CUSTOMER ADVISORY

ADV2516

Changes to Packing Materials of Altera Products

Issued: 12/18/2025

Sample images showing the inner box change

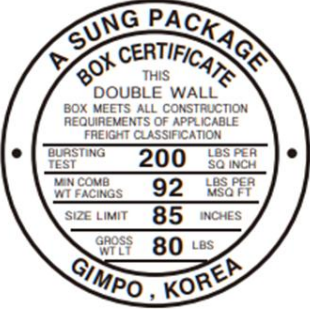
Packaging Material	Updated Details
Inner Box	Removed the "Intel" logo and introduced a new supplier; box color may vary slightly.
Packing Strapping Band	Strap width changed from 15mm to 12mm.
Outer Box	Added a new supplier.

Inner Box: Existing Supplier	Inner Box: Existing & Additional Supplier
